3592 WEST 29TH AVENUE (COMPLETE APPLICATION)
DE418296 - ZONE C-2

DEVELOPMENT PERMIT STAFF COMMITTEE MEMBERS

DEVELOPMENT PERMIT STAFF COMMITTEE RECOMMENDATION: APPROVE

Figure 3: South Elevation

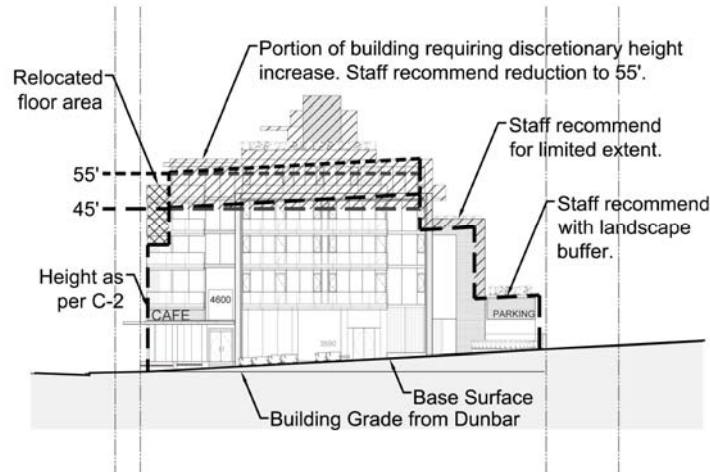
1.3 design development to the south elevation to reduce the appearance of building mass;

Note to Applicant: This can be achieved by reducing the depth of the south roof deck at the uppermost level so that it does not project into the 2.4m setback. Further, the west building walls adjacent to the plaza should be set back above the lower level.

The scale of south elevation has been the subject of concern from residents. Measures have been undertaken in the proposal to reduce the apparent scale - approximately two-thirds of this elevation is setback by approximately 26 ft. The remaining one-third generally complies with the required setbacks, with the exception of the fourth (labeled third) floor, where a balcony and concrete frame cornice project. With recommended condition 1.1 which reduces the proposed height of the building, and recommended condition 1.3 which ensures that the uppermost level complies with the setbacks,

the scale will be reduced, and Staff support the limited projections noted above. To further reduce the apparent scale, and to increase amenity of the public plaza, recommended condition 1.3 asks that the south-facing walls above the public plaza be stepped back.

Figure 4: West Elevation

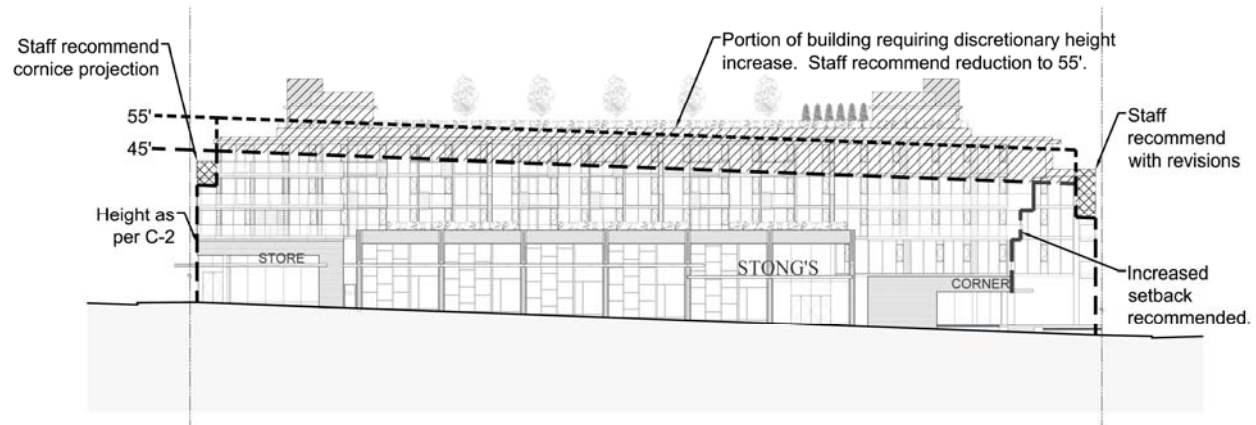
1.4 design development to the west elevation to increase variety at the residential levels;

Note to Applicant: The proposed south elevation is successful in articulating three distinct façade expressions. This condition can be met by further developing the approach to articulation in the middle portion of floors 2 through 4. This can be achieved through the revised distribution of materials, and balconies or other means.

For typical C-2 development sites, a front yard of 2 ft. is required to the 35 ft. height mark and above that an 8 ft. setback is required. The 2 ft. yard is considered a "build-to" line in order to assist with street enclosure. The increased upper level setback is to reduce apparent scale and ensure natural light for the public street. This proposal provides the 2 ft. setback to approximately 20 to 30 ft. in height, and above that begins the increased setback of 8 ft. There are balcony projections into the increased setback. This approach is generally supported by the C-2 Guidelines in order to provide building articulation. Recommended Condition 1.4 recommends further design development to focus the approach of articulation.

Landscape Sections and Details

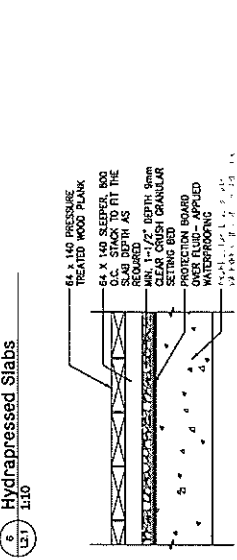
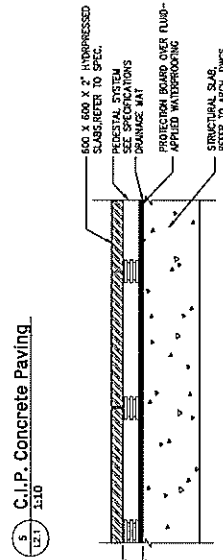
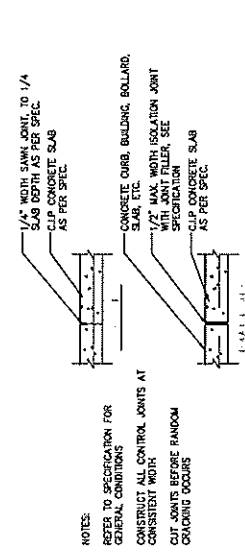
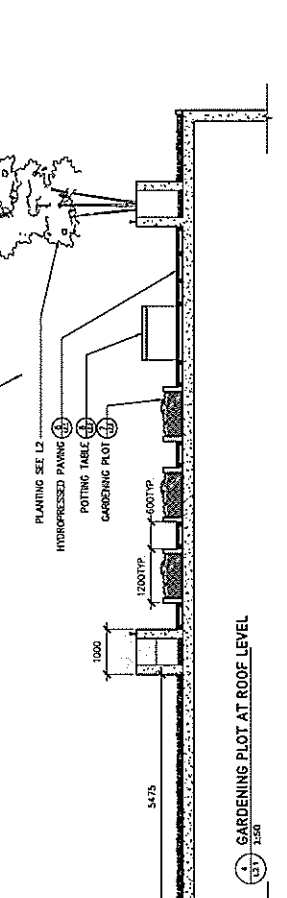
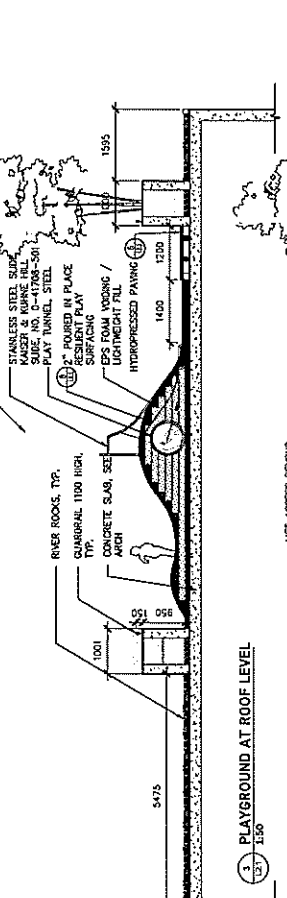
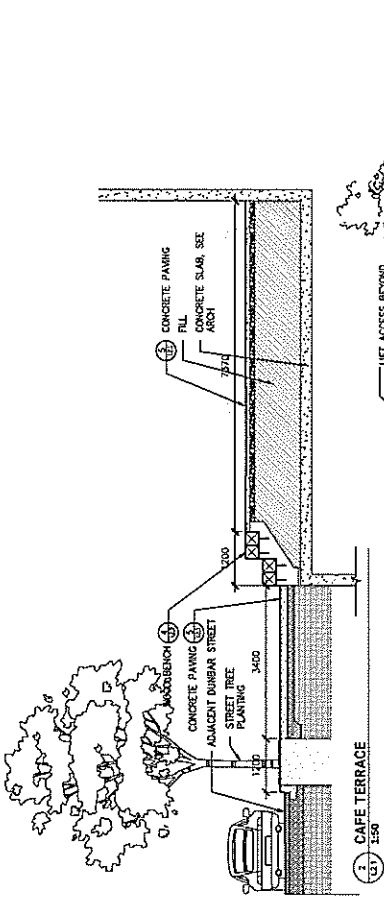
Note to Applicant: Detail 5 on drawing L2.1 specifies 'sandblast finish as per spec'. Drawings and specs should be revised as required.

Planting Details

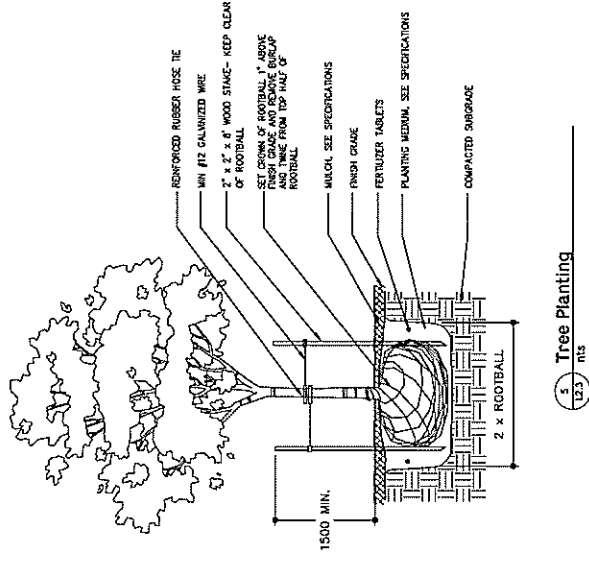
- A.1.16 clarification of landscape section 4, sheet L2.3;

Note to Applicant: The section illustrates the planting for bamboo to be on slab, while the architectural/landscape plans suggest the bamboo will be located in an enclosed planter.
